**SECRET HARBOUR PROJECT**

**BULLETIN 121**  
**AUGUST 1982**

ENVIRONMENTAL REVIEW AND MANAGEMENT PROGRAMME

### PLAN 3

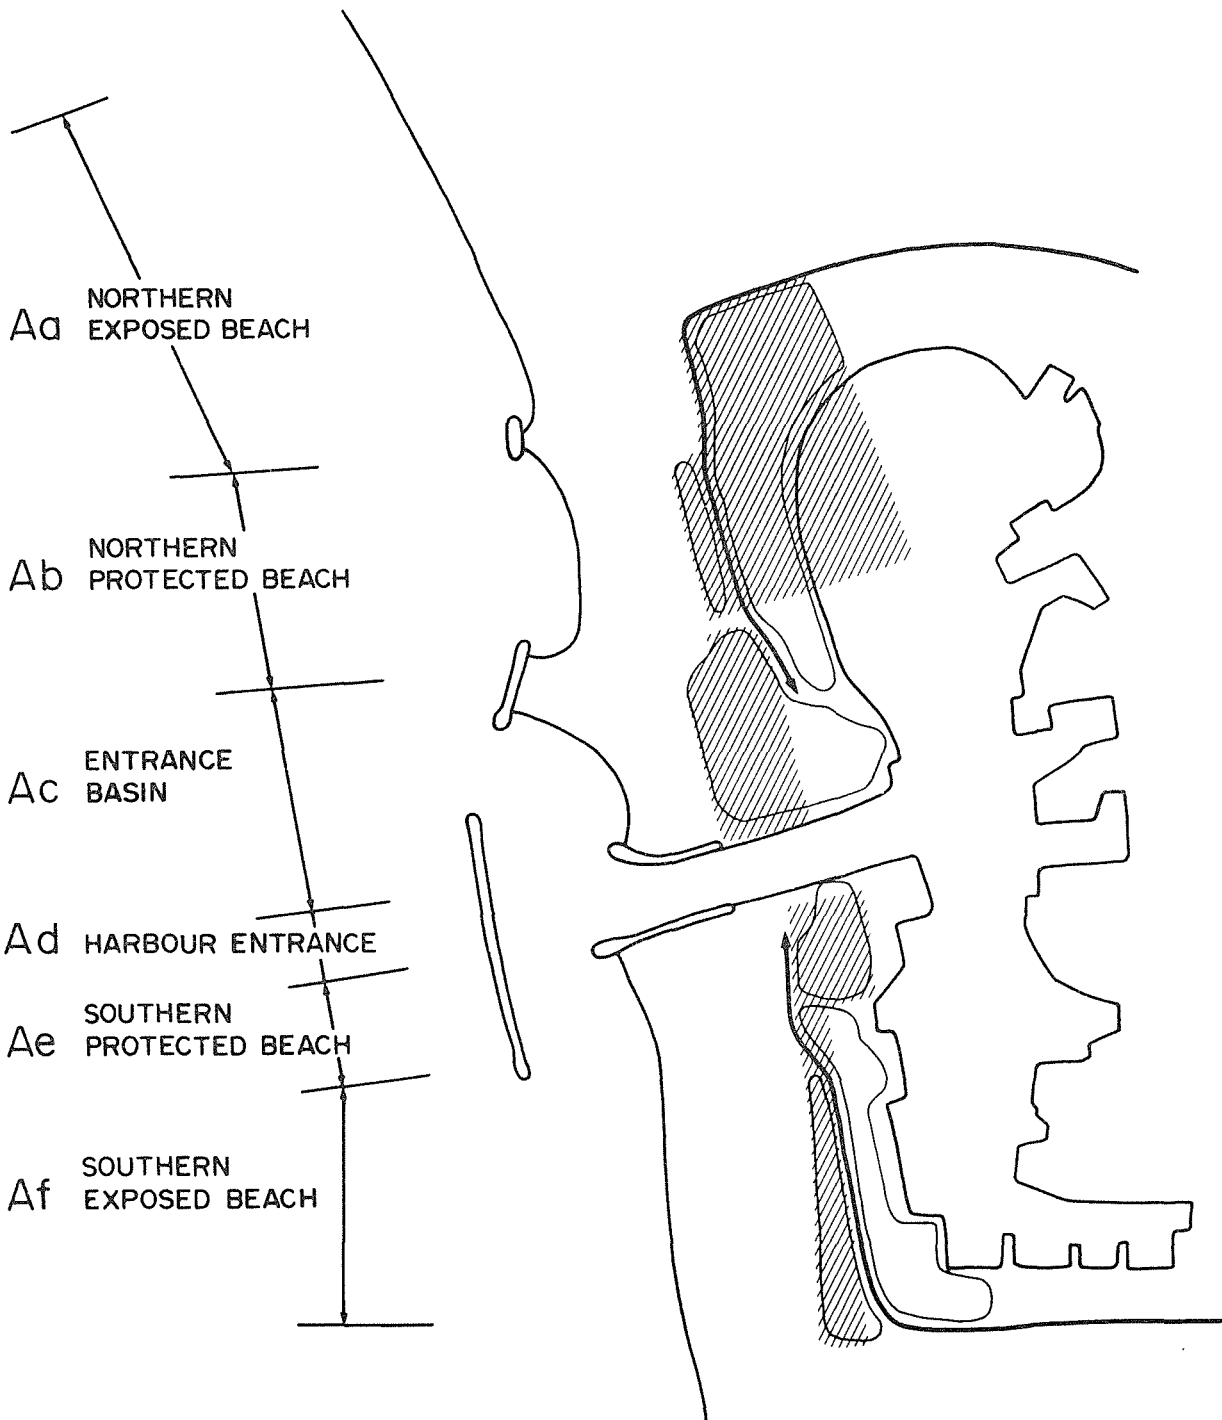
- Rec. 2 *A reduction in the present reserve for Parks and Recreation (under the Metropolitan Region Scheme) should not be permitted until a firm and irrevocable commitment by the proponents has been made to construct and maintain the breakwaters and sand by-pass system as generally shown in the ERMP and as refined by subsequent detail design. When these requirements have been met, the rezoning could occur within the area defined by the dotted line on Plan 3.*

- Rec. 3 *Rezoning of sections of beach front (as shown in D8.1 of the ERMP) should not be approved until the following conditions have been met:*
- . Section Af. No additional rezoning within 100 metres of the present shore vegetation line until detail design of the entrance and sand by-pass system has shown that a lesser foreshore reserve will provide adequate public access and erosion protection.*

- . *Section Ae. No additional rezoning within 150 metres of the present shore vegetation line until detail design of the entrance and sand by-pass system has shown that a lesser reserve will provide adequate public access and erosion protection.*

- . *Section Ad. The width of the harbour entrance should not be limited by zoning or development until the detail design of the entrance (including allowances for possible harbour extensions) is complete and is shown to be adequate. Development could however, occur on one side of the entrance.*

PLAN 4

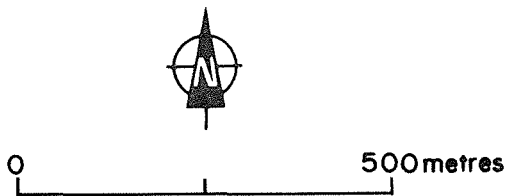
- (2) *No rezoning within 200 metres of the present shore vegetation line until a specific sand by-pass operation has been proven to provide long term stability to this beach, and the 'Node' as identified in the ERMP has been proven to be stable in the long term.*

*Plan 4 represents graphically Recommendation 3.*

Areas which should not be Rezoned until the Requirements of Recommendation 4 have been met.
